CERTIFICATE OF APPROPRIATENESS

Property: 1913 B Crockett St, Lot 11A, Block 314, Shearn Addition Subdivision. The property is a vacant interior lot, subdivided into two lots, Lot A that measures 2,534 square feet (51' x 50'-4") and Lot B that measures 1,608 square feet (37'-8" x 42'-8").

Proposal: New Construction – Residence/Garage

Construct an approximately 2,380 square foot two story residence and attached garage at the rear of the lot.

BLOCKFACE RENDERING – FRONT FACING CROCKETT STREET

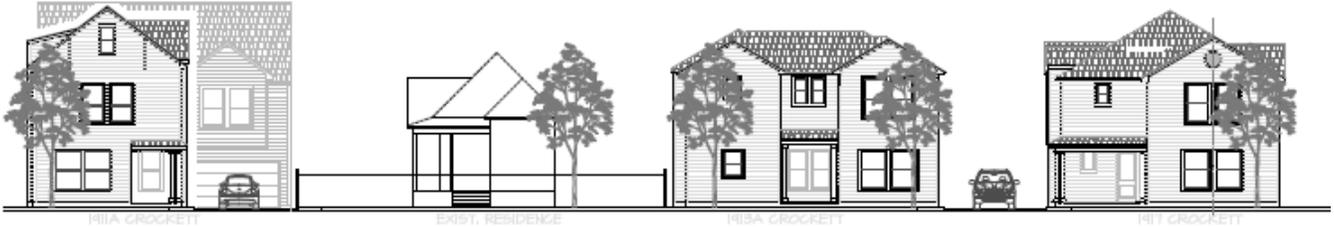
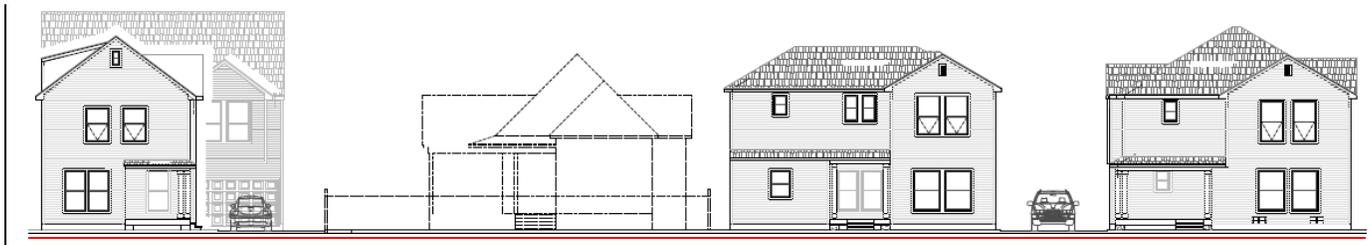
- 2.1. The contributing structures in the High First Ward Historic District include both single-story and two-story structures. However, it is not a random mixture; single-story structures are overwhelmingly prevalent. In fact, there are only two two-story contributing structures in the District: 1809 Summer and 2007 Shearn. Everything else is single-story. The overall proposal to add no fewer than five two-story structures in close proximity to each other is highly unbalanced and not compatible with the contributing structures in the District. Worse, the

existing historic structure at 1907 Crockett would be sandwiched in the middle of all this new construction which would loom over it, resulting in a classic example of what historic districts are intended to avoid.

SITE PLAN

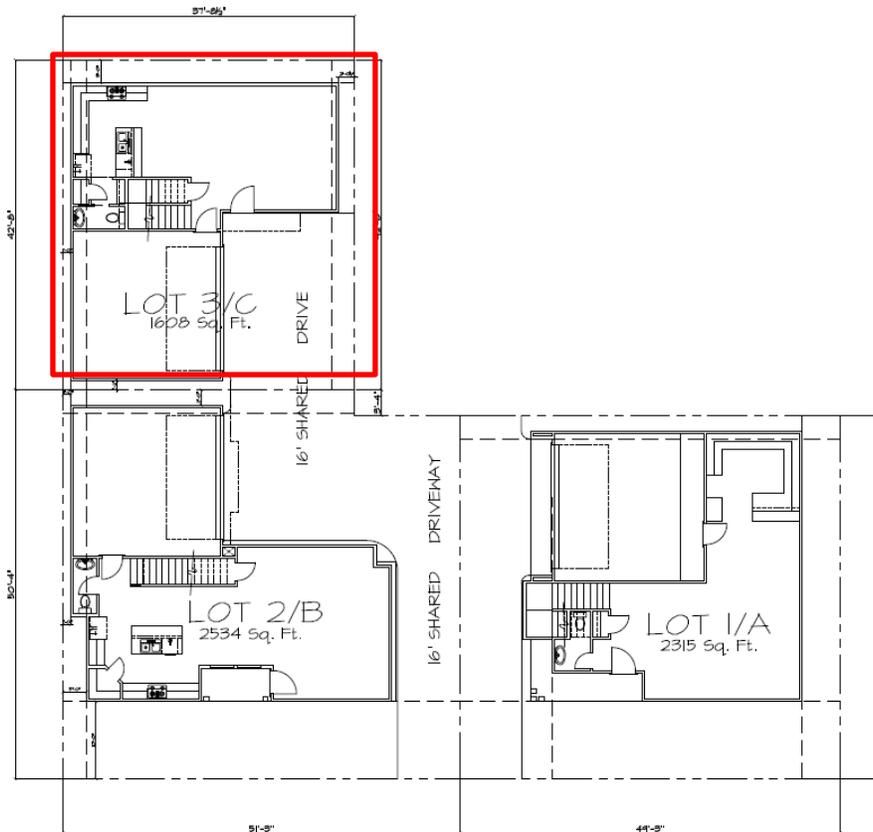
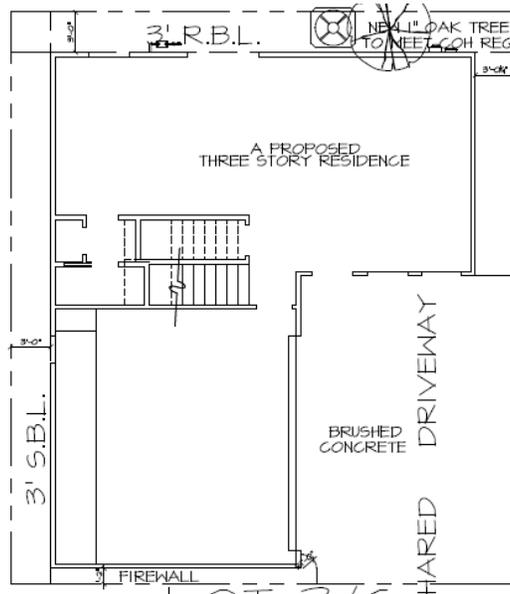
- 1.1. A site plan is required for a COA application. Each of these applications includes a drawing labeled "Site Plan". However, these purported site plans do not indicate the orientation of the proposed buildings to the surrounding streets or to each other. In addition, the elevations are listed as "left", "right", etc. instead of the usual "north", "south" etc. All this is contrary to industry standards, and makes the site plans very difficult to decipher. This needs to be addressed in order to make the proposed plans more readily understandable.

- 1.2. Given the close proximity and interrelationships of the proposed buildings with one another, a site plan should be provided that covers all the buildings in the project so that what is being proposed can be understood.

- 1.4. The historic/contributing structure at 1907 Crockett is known to encroach on its neighbor to the west (1913 Crockett). This encroachment is not shown on the site plan. This omission is significant, since it affects the actual distance that will separate the new structure at 1913 from the existing one at 1907.

- 1.5. A 10' setback from the street is noted. This is out of character for the District, where setbacks of 15 feet or more are prevalent on contributing structures. Is this permissible?
